**Re: 131, 139, Parkdale Ave and 128 Forward Ave – Urban Design Review Panel Recommendation**

On January 9<sup>th</sup>, 2026 at 9:00am we presented our proposal for a new development located at 131, 139 Parkdale Ave, and 128 Forward Ave. on behalf of our client 11034936 Canada Inc. (Brigil). Included below are our responses to the recommendations made by the City of Ottawa Urban Design Review Panel, dated January 9<sup>th</sup>, 2026.

## **Re: 131 Parkdale Avenue - UDRP Comment Response to Landscape Items**

# 131 Parkdale

# Level 01 Floor Plan

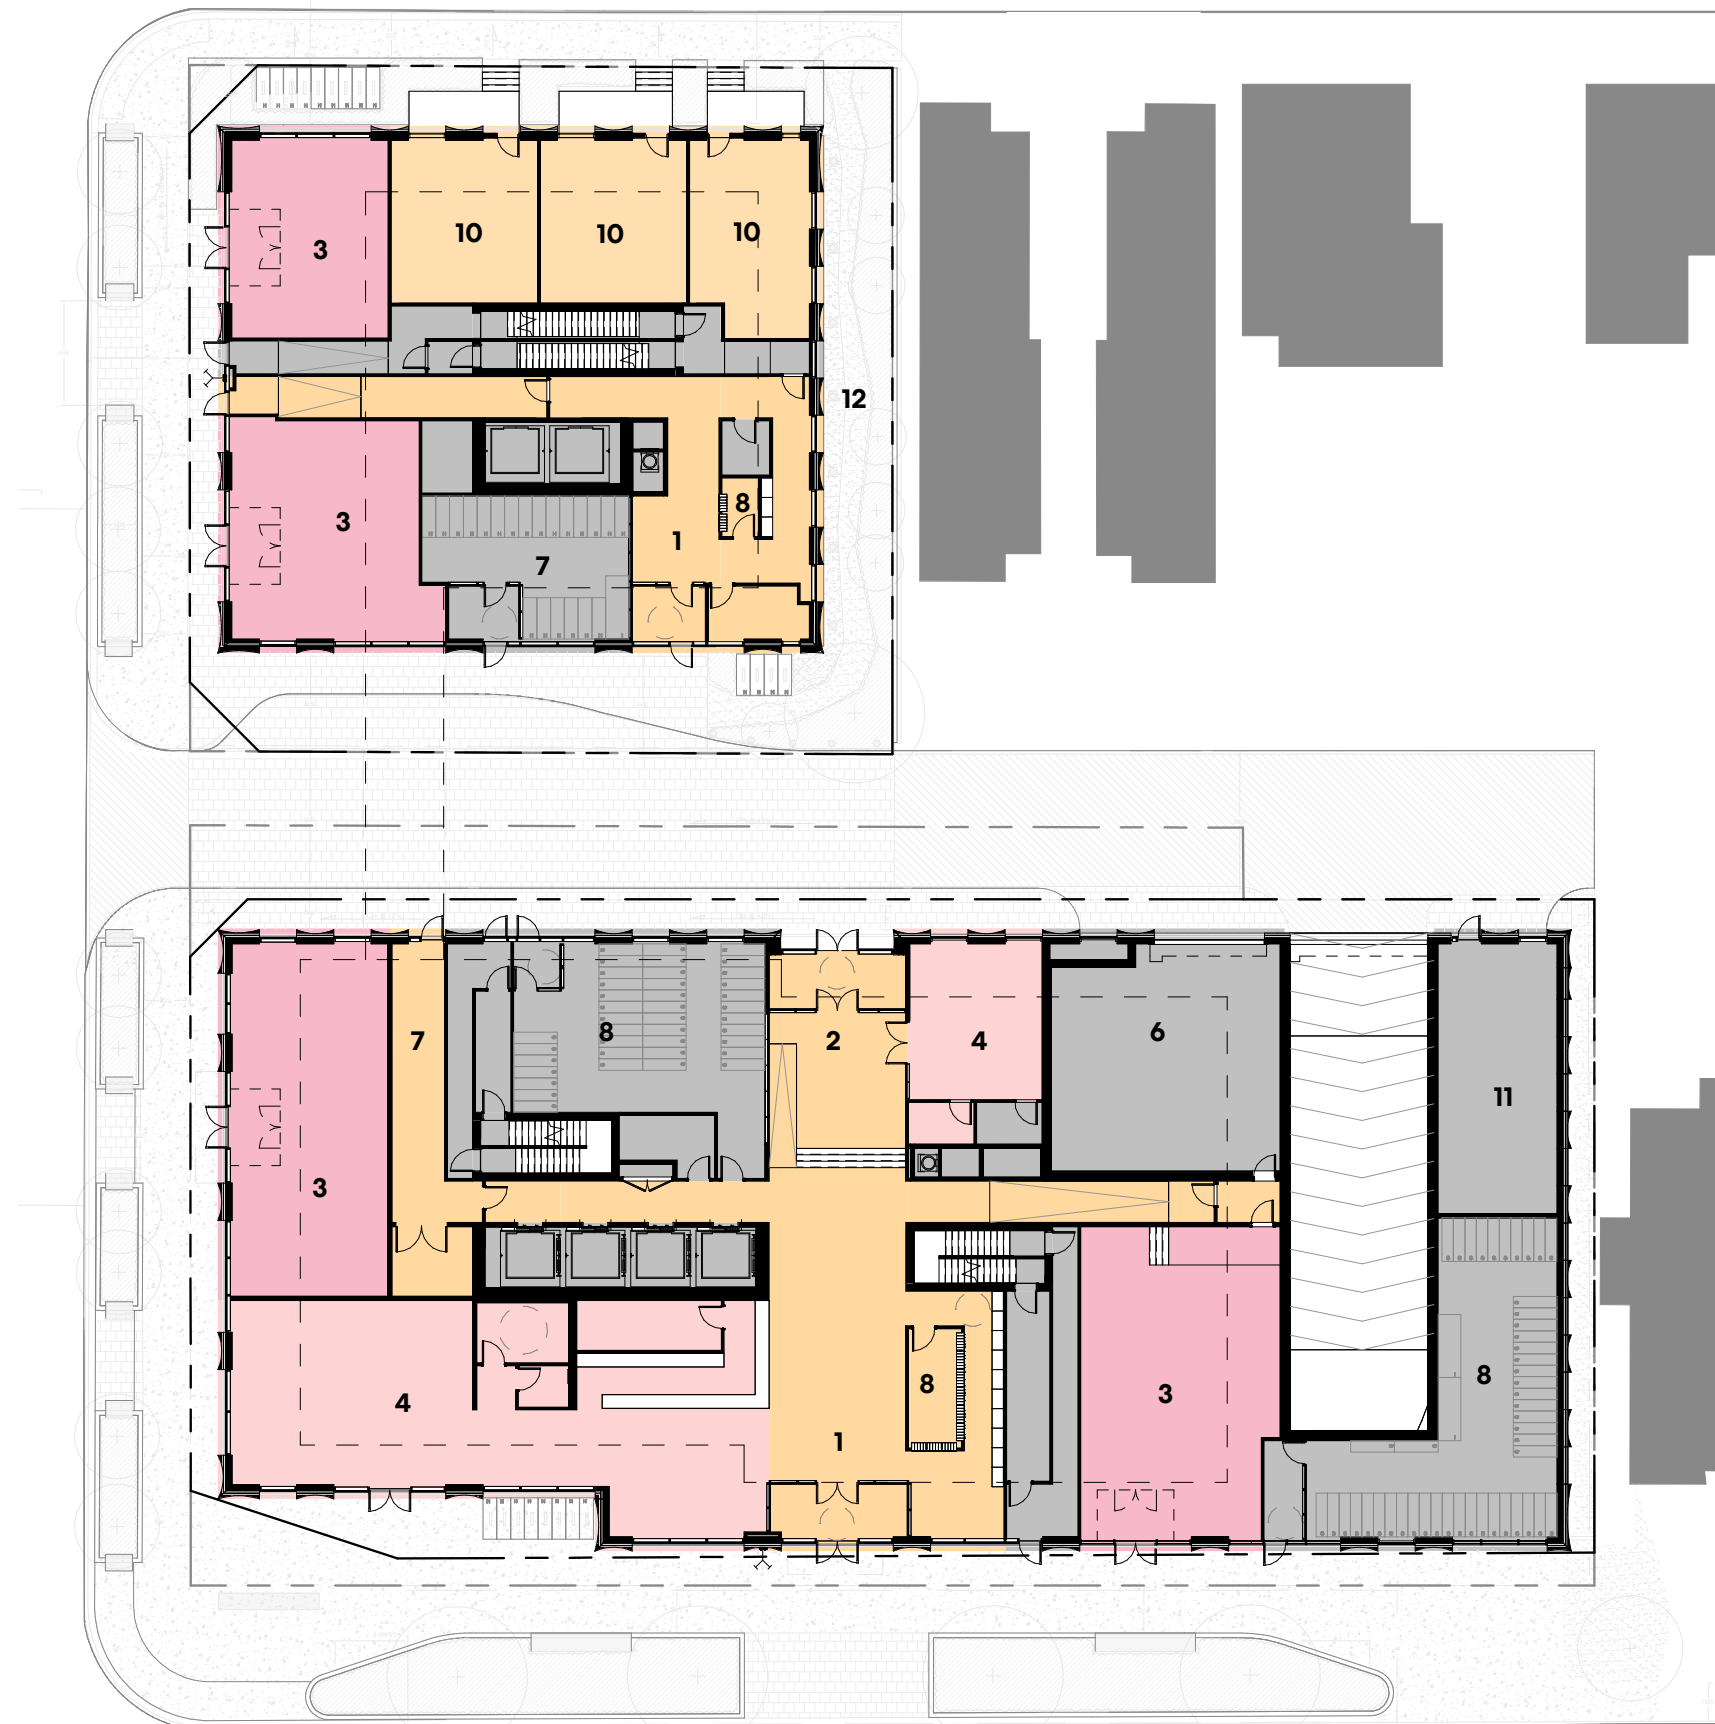
| <p>The Panel encourages further exploration of the lobby placement along Parkdale Avenue to create a more active street edge and advises that back-of-house such as mail room, not present as a public-facing, ensuring a clear and civic expression.</p>   | <p>The location of the lobby has moved further to the south, in the centre of the Building B. The lobby extends through the ground floor and connects directly to the laneway. Amenity at grade is envisioned to extend into the lobby creating a third space for residents and potentially the community at large. “Back-of-house” functions, such as the mail room have been pulled back from the exterior, while space such as the bike room are celebrated towards the laneway with vision glass showing off this active transportation space.</p>   |

| <p>The Panel encourages exploration of the bike rooms along the laneway as more than utilitarian spaces, suggesting glazing, visibility, or active uses such as bike repair to animate this central pedestrian corridor.</p>   | <p>Noted. The project will prioritize access or cycling and other modes of active transportation. Bicycle rooms will be design as more than utilitarian space, celebrating bicycling and provide windows to the laneway creating a visual connection between the two spaces. Opportunities for glazing between the bike room and the interior will also be explored.</p>            |

| <p>The Panel expressed some concern that part of the passageway may be need for vehicular maneuvering.</p>   | <p>The passageway has been removed. Vehicle movements will take place within the laneway only.</p>  |

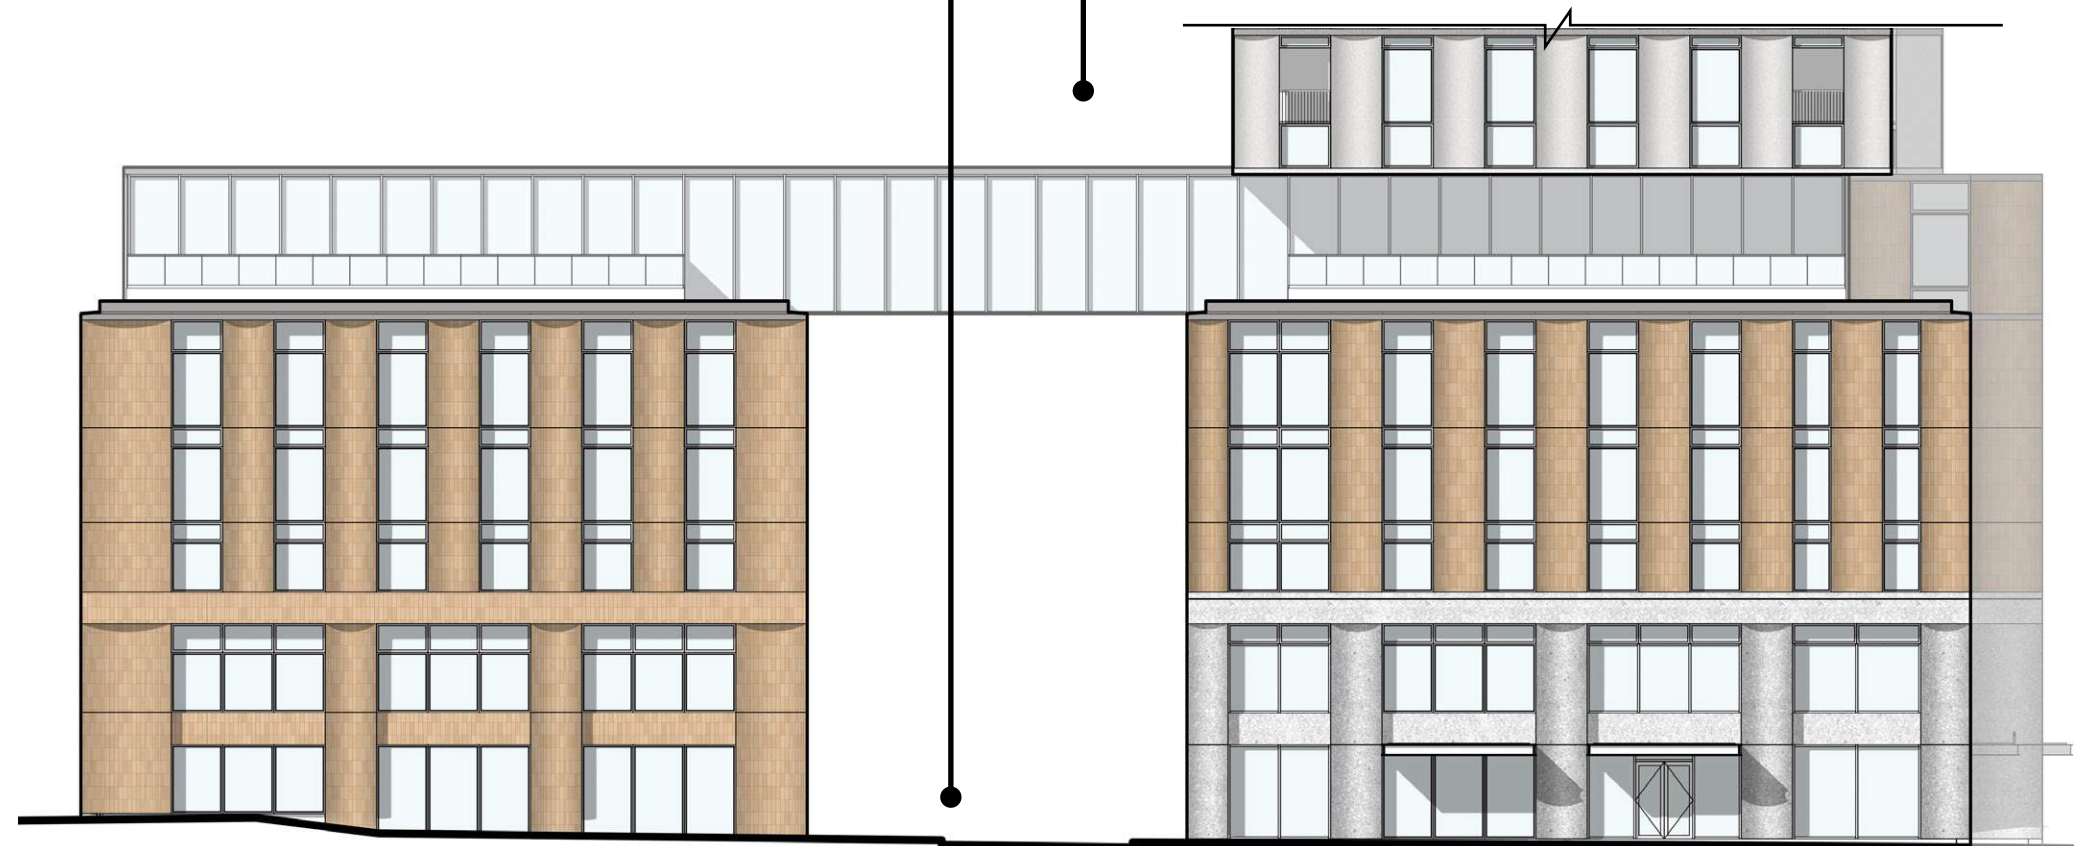
Parkdale and Burnside corner setback to allow for site triangles

Ground floor at Foward and Burnside changed to Brick Cladding

Canopies at entries
